PROJECT: Olan K. Grayson Elementary School Addition

CITY OF LAS VEGAS		DATE:
INTER-OFFICE MEMORANDUM		December 22, 2020
TO: Land Development Services Department of Building & Safety		FROM: Albert Sung, P.E. Flood Control Project Engineer Department of Public Works
SUBJECT:	Drainage Study for:	COPIES TO:
	Oran K. Gragson Elementary School Addition	Lochsa Engineering
Cross Streets:	SEC of Bonanza Road & Honolulu Street	School Board of Trustees
File Number:	F:\Depot\DSMemos\DS5392A.doc	Bart Anderson, P.E., DevCo
Parcel Number:	140-31-102-003	
Zoning Action:	XXXXX	
FEMA Flood Zone	YES NO X	
Proposed Storm Drain	YES NO X

Subject: **Technical Drainage Study for Oran K. Gragson Elementary School Addition**
Lochsa Job No. 201091

SHEET NO: DR1
SHEET 1 OF 2

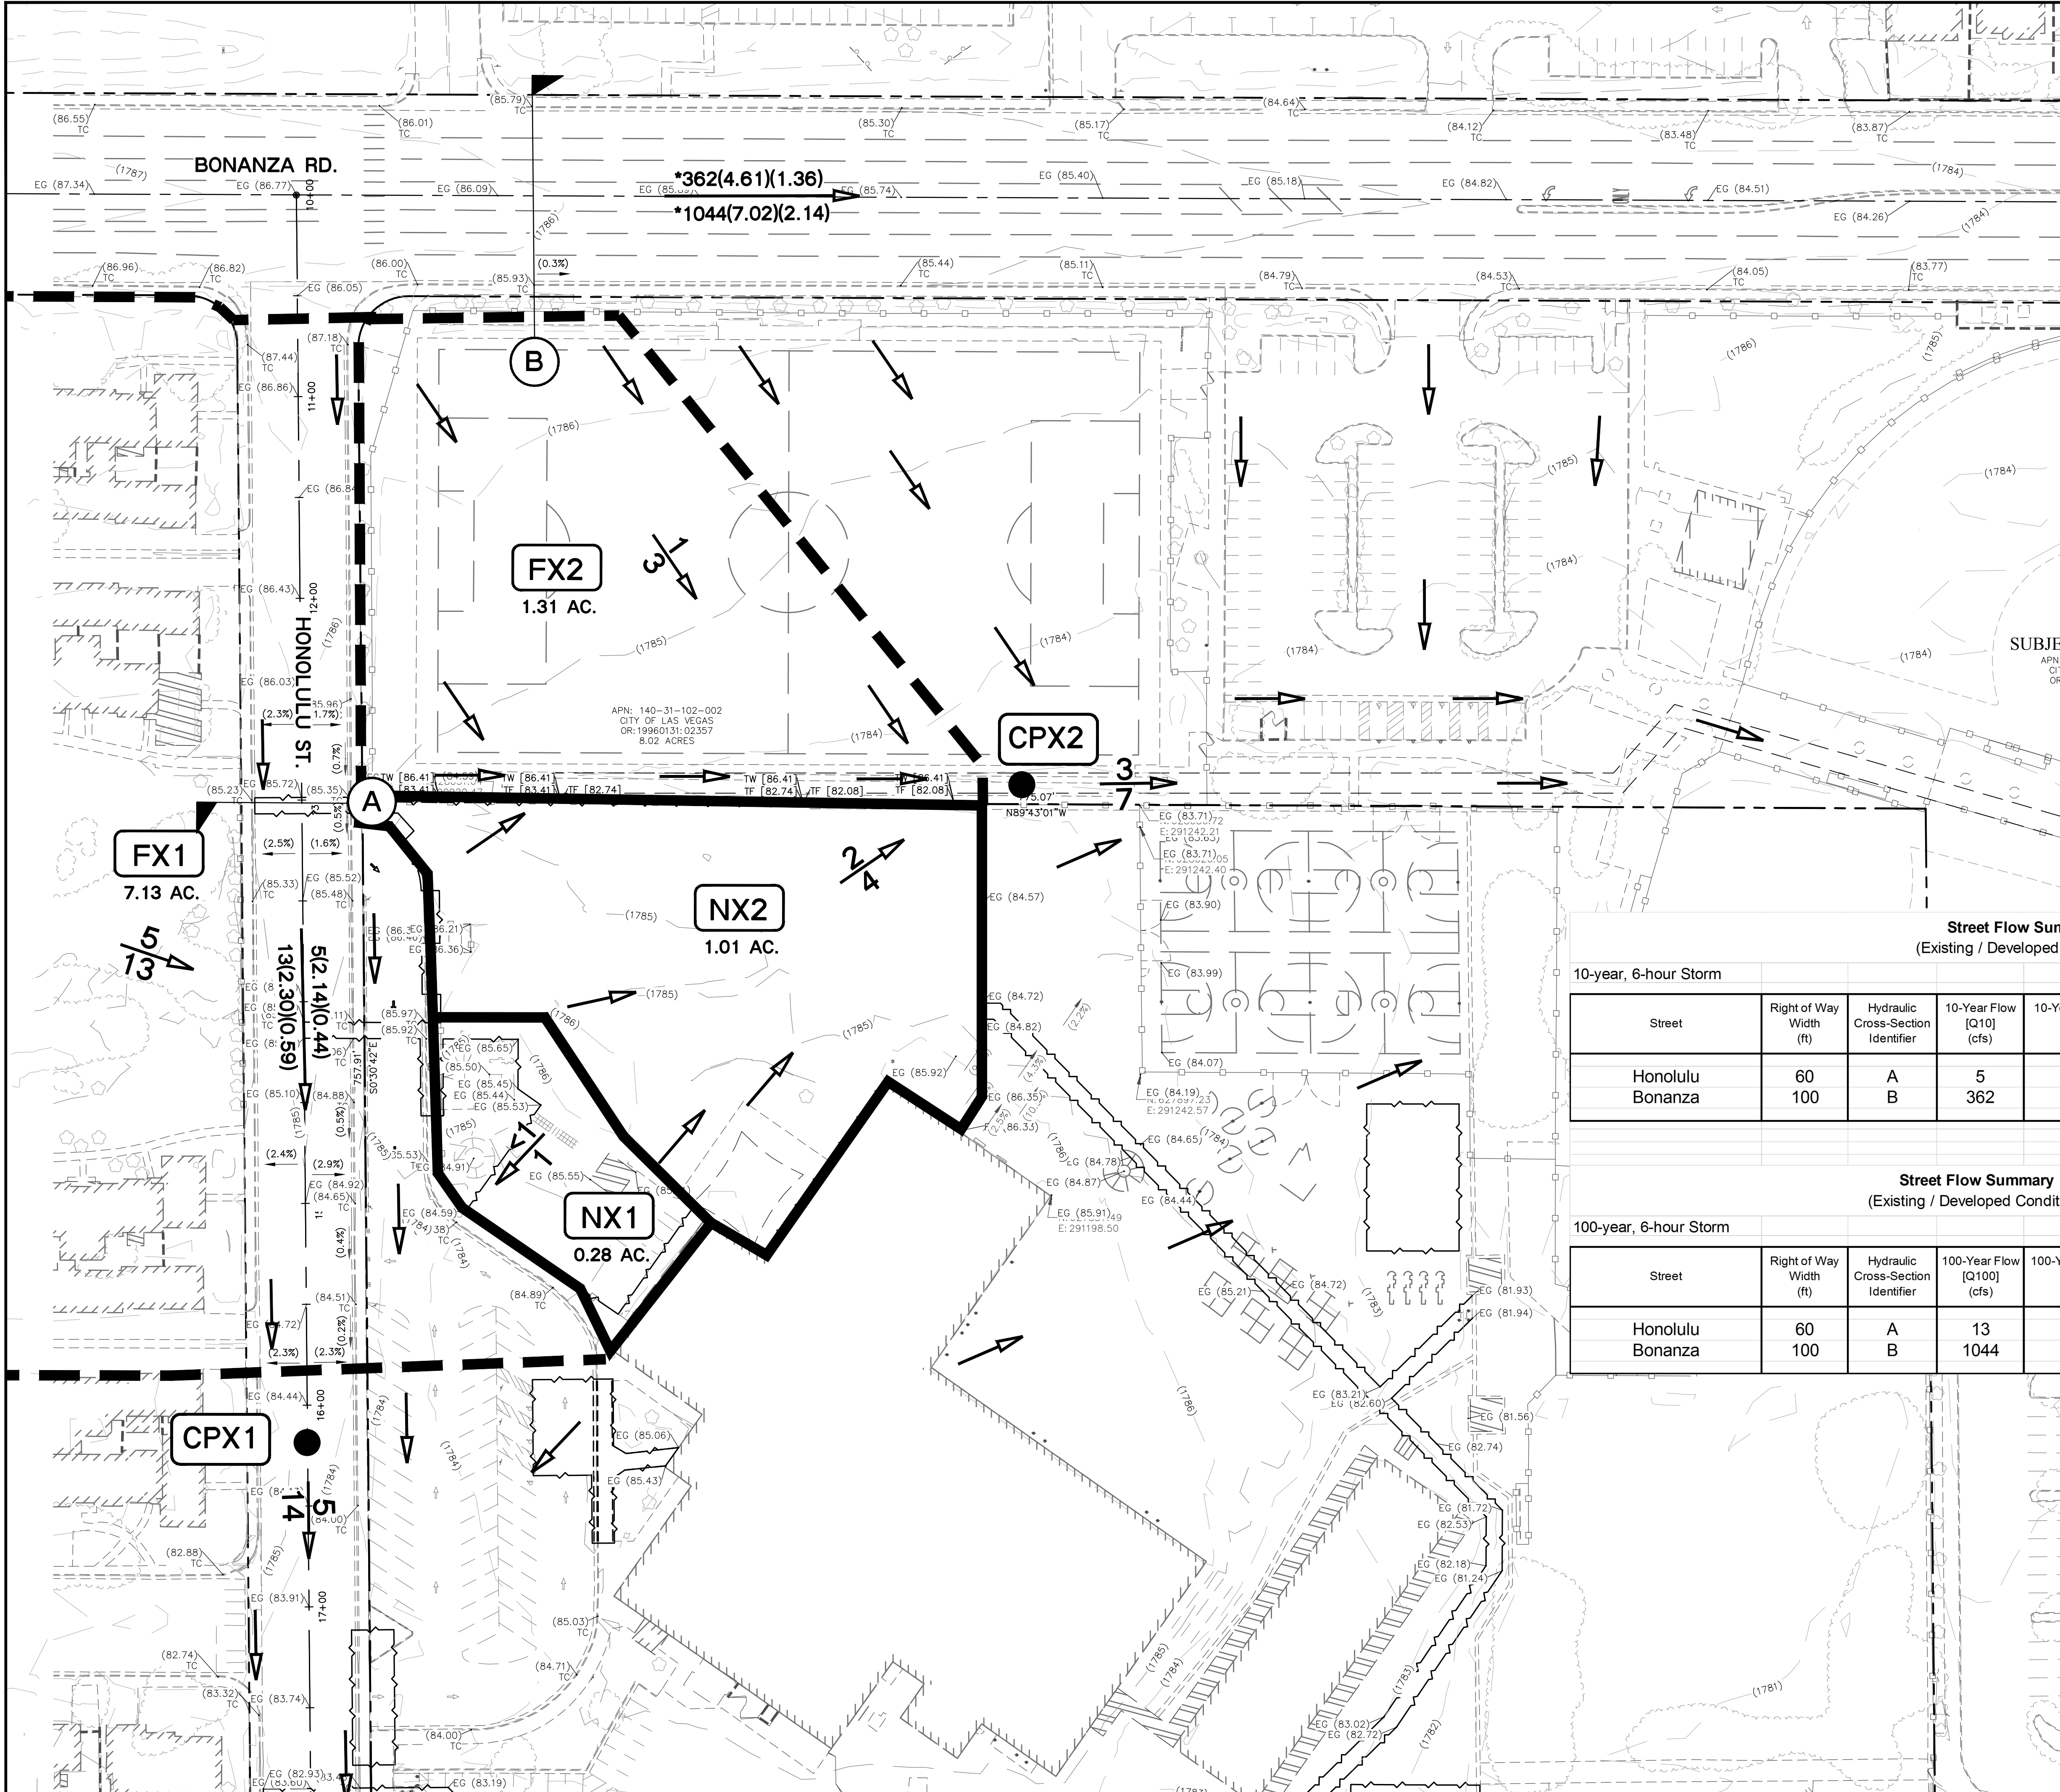
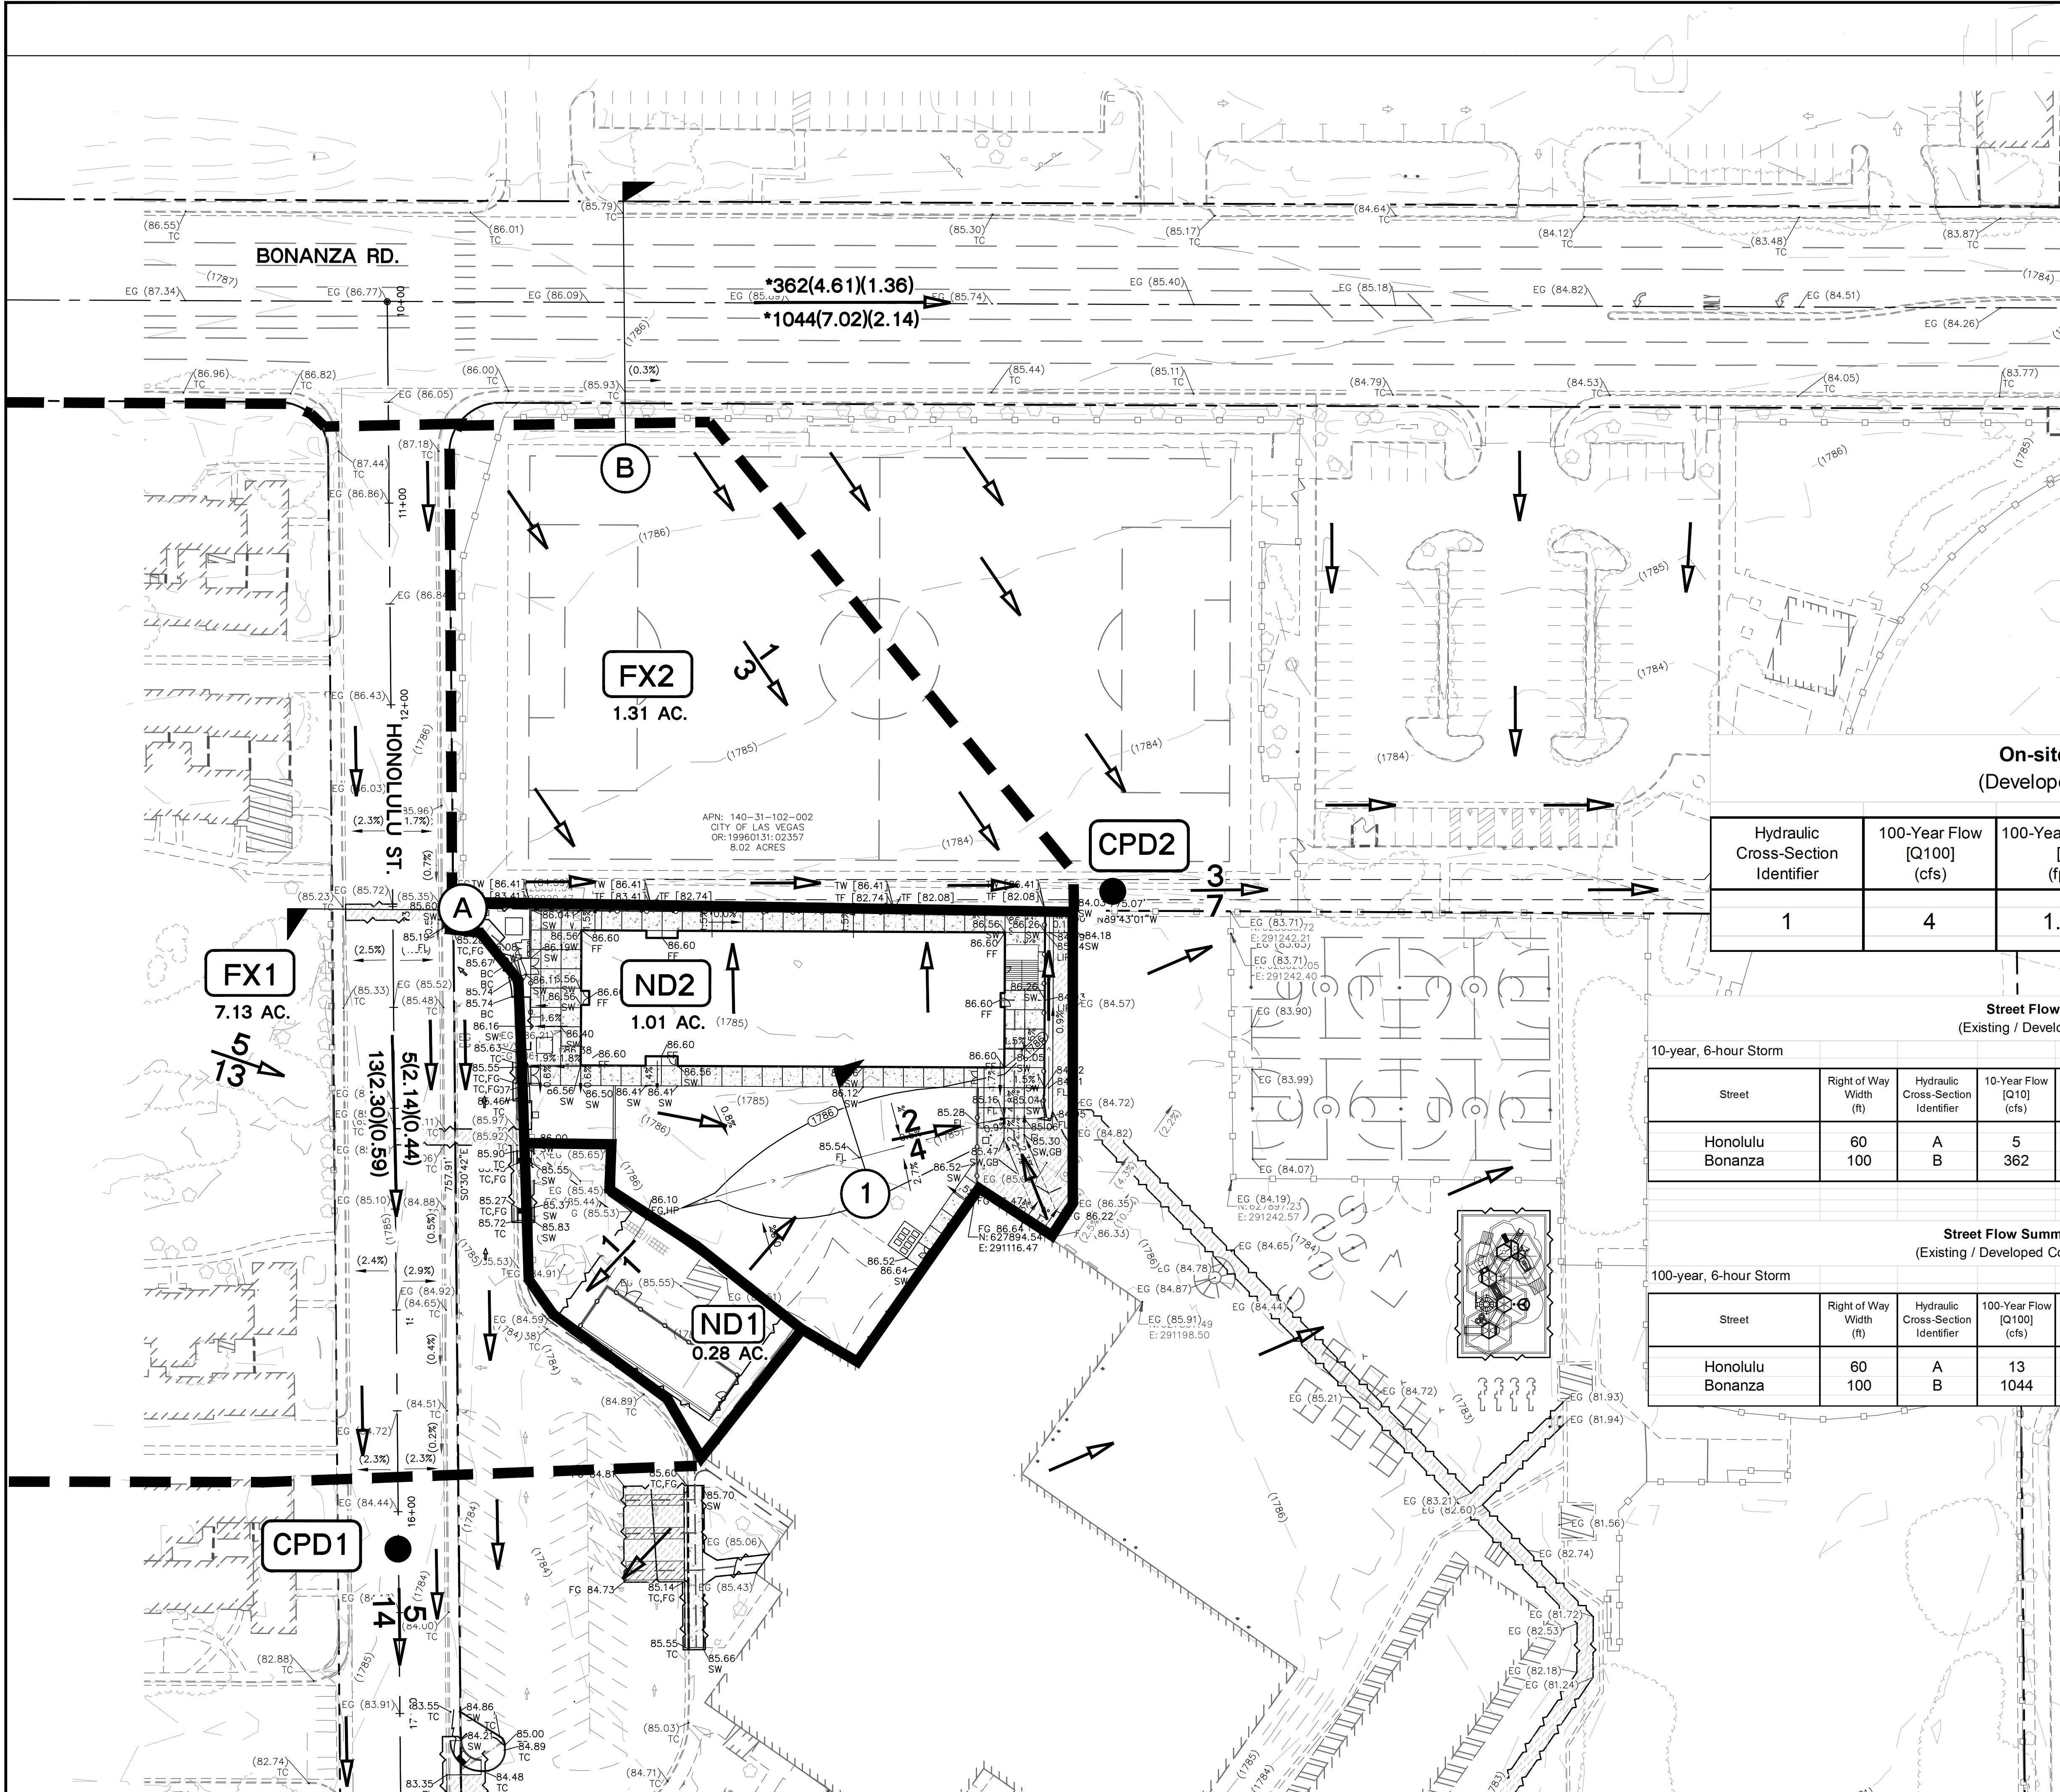
In **DR1** and **DR2** (Existing and Developed Conditions Onsite Drainage Maps), *Basin FX1* was shown. However, without showing the whole basin and pertinent topographic information, it was not justifiable to merely stating that the basin area is limited to 7.13 acres. Resolve in the next submittal.
